STAFF REPORT
(One-Step Final Plat)

CASE NUMBER: S/D 99-1 - WEST WAREHOUSE 2ND ADDITION

LOCATION: East side of West St., South side of Harry

VICINITY MAP

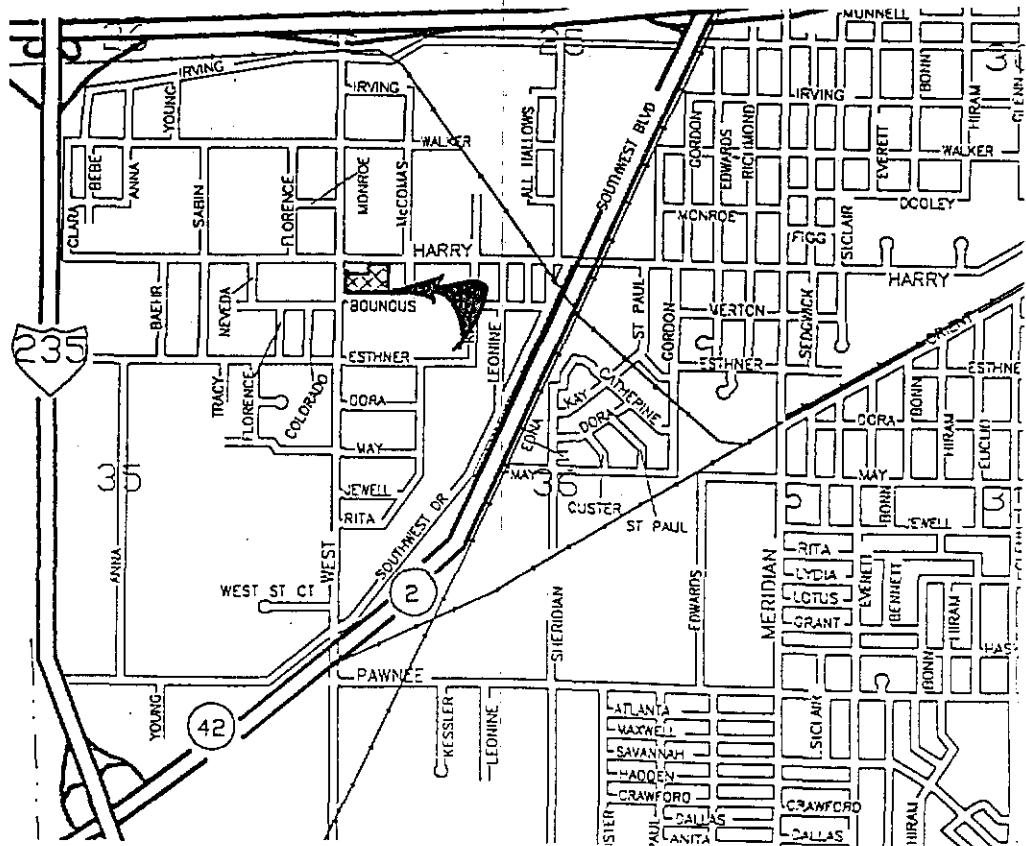
Handwritten notes:
F R/W
Cross Lot drainage agreement
L-173

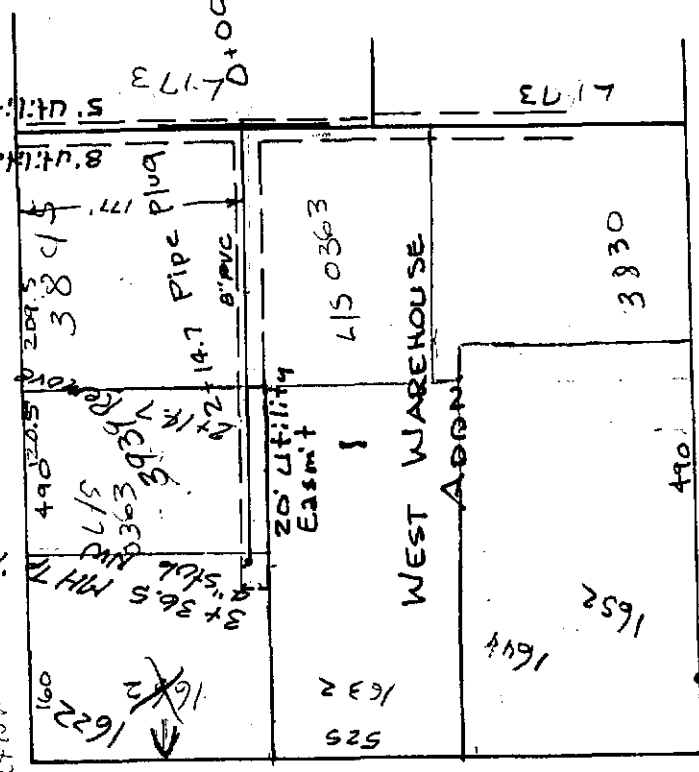
The existing sanitary sewer in Lot 1, West Warehouse Addition lies near the south line of Lot 2, West Warehouse Addition, as was determined by a field survey. The sewer line falls within the proposed sanitary sewer easement. The proposed easement is at the same location as the existing easement.
